**SAFETY EVALUATION REPORT
FOR RENEWAL OF
SOURCE MATERIAL LICENSE NO. SUA-1341**

**COGEMA MINING, INC.
IRIGARAY AND CHRISTENSEN RANCH PROJECTS
CAMPBELL AND JOHNSON COUNTIES, WYOMING**

JUNE 1998

**U.S. Nuclear Regulatory Commission
Office of Nuclear Material Safety and Safeguards
Division of Waste Management**

Figure 4-1 - Irigaray Site: Survey and Sampling Locations

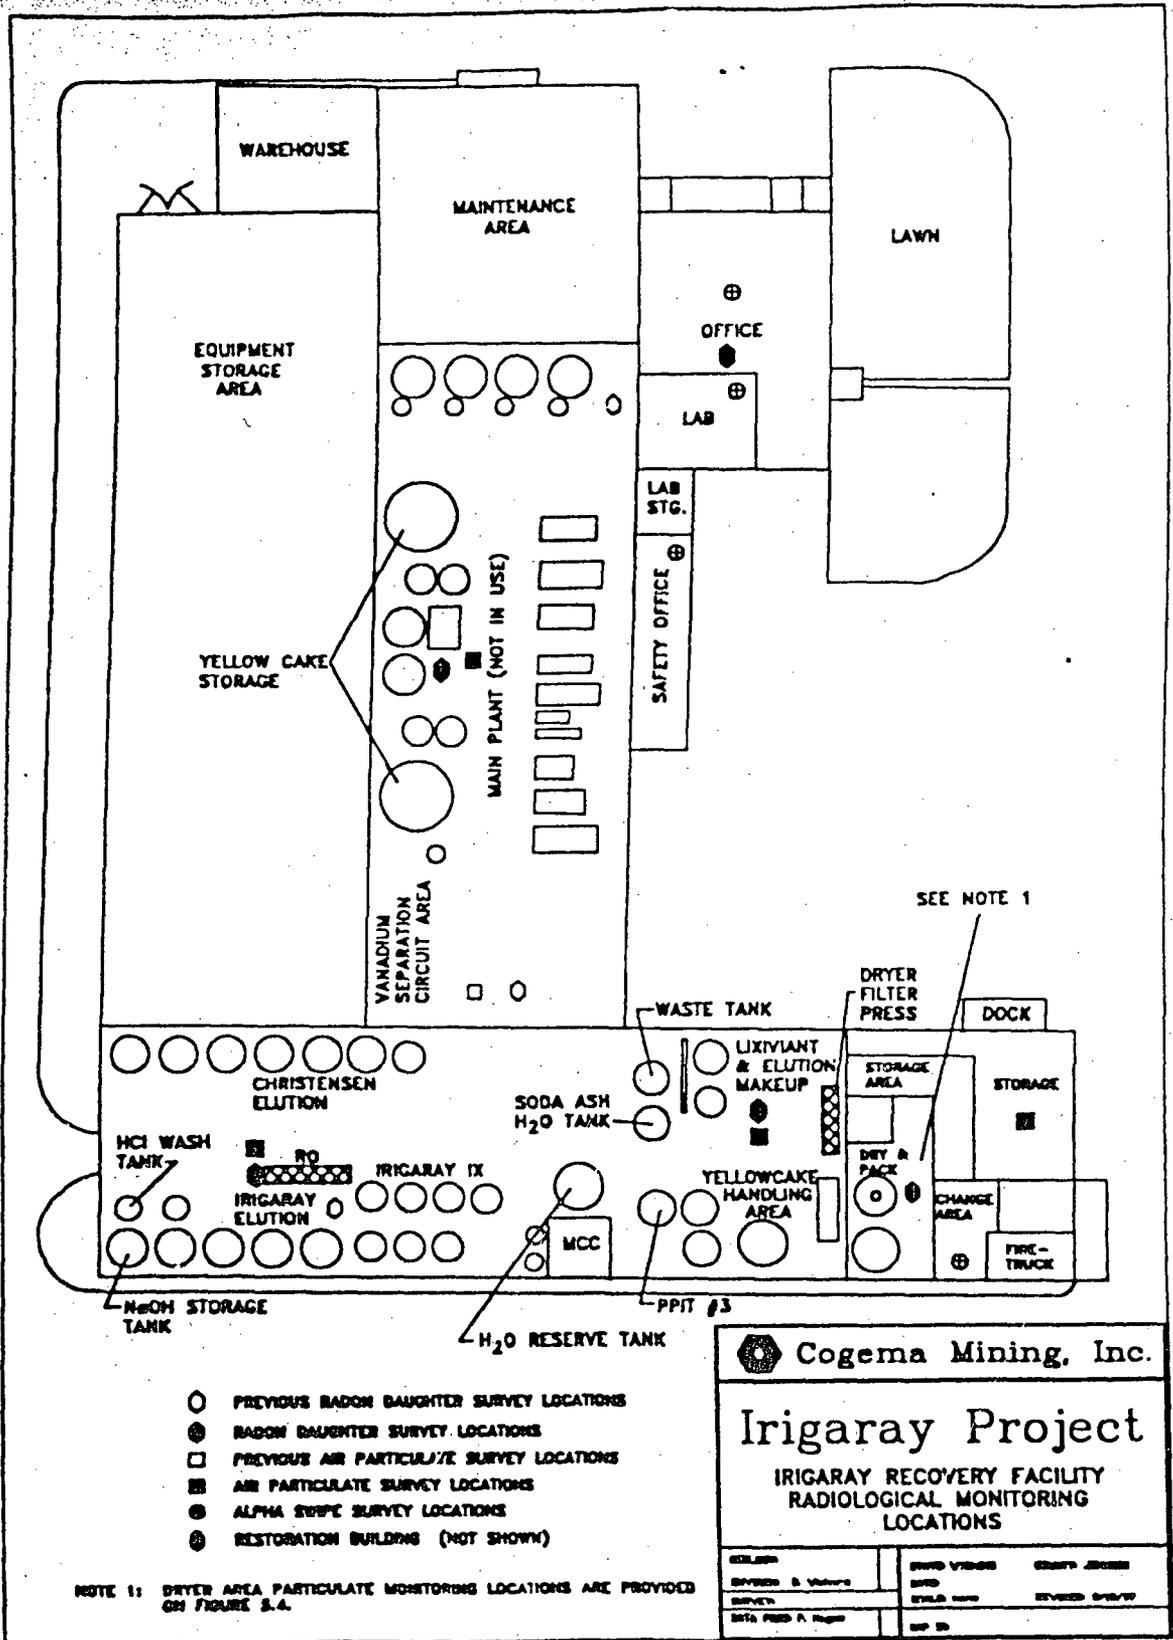
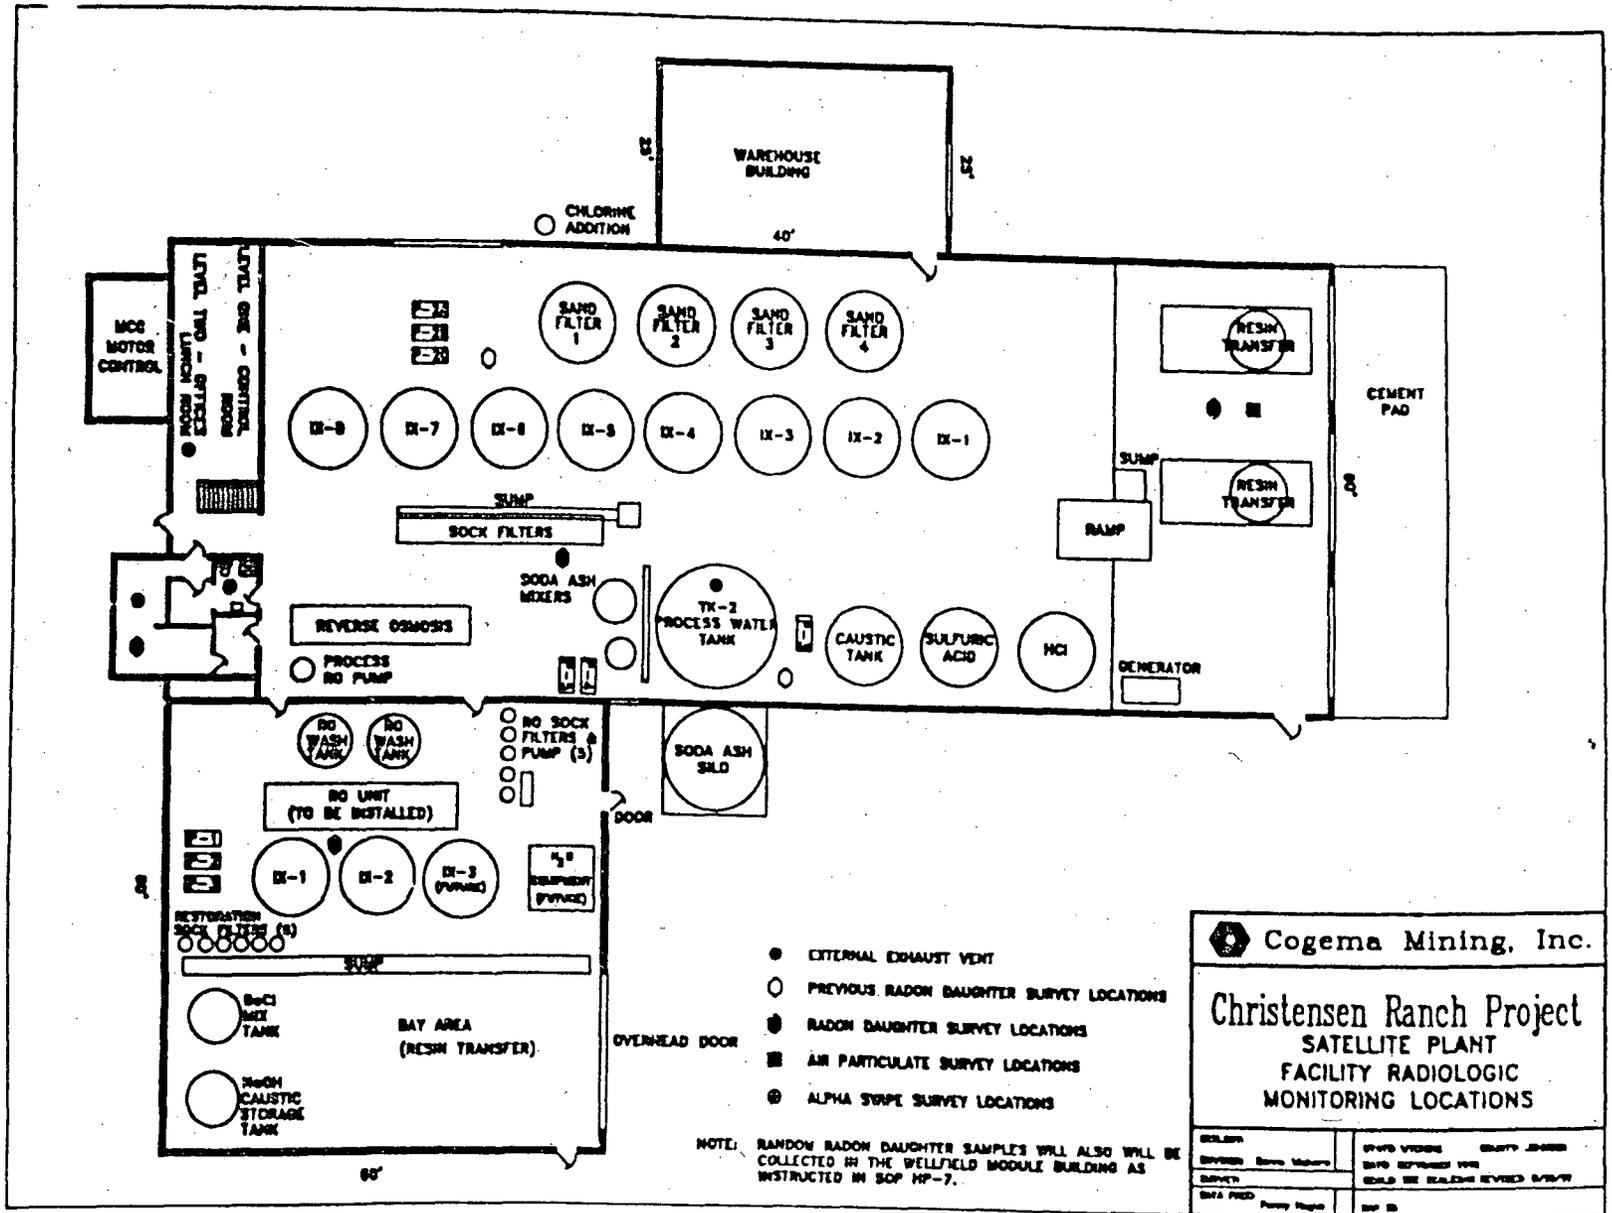
Monitoring for airborne uranium is performed routinely at the Irigaray and Christensen Ranch facilities through the use of area sampling and breathing zone sampling. In the LRA as revised, COGEMA proposed to change the locations of some of its air sampling equipment based on actual data and historical program results. The proposed locations of radon gas sampling equipment and the uranium particulate sampling equipment for the Irigaray and Christensen Ranch facilities are shown in Figures 4-1 and 4-2. In addition to the locations shown in these figures, samples are to be taken at new locations in the dryer room during dryer operations (Figure 4-3). NRC staff has reviewed the locations proposed by COGEMA for the renewal and agrees they may provide more accurate monitoring of in-plant radiological conditions than the currently specified locations. The NRC staff finds the new locations to be acceptable. Samples will also be taken whenever RWPs are issued.

COGEMA has conducted monthly in-plant radon daughter surveys at specific locations in the operating areas of the Irigaray and Christensen Ranch facilities. Using historical program results which show the average radon daughter activity at Irigaray and Christensen Ranch has been generally less than 5% of the regulatory limit, in the LRA as revised, COGEMA proposed to change the locations of the radon daughter sampling stations to improve the accuracy of the information collected. NRC staff finds these new locations to be acceptable.

The staff finds that the COGEMA in-plant monitoring program, including the new sampling locations proposed in the revised LRA, is in accordance with the ALARA concept.
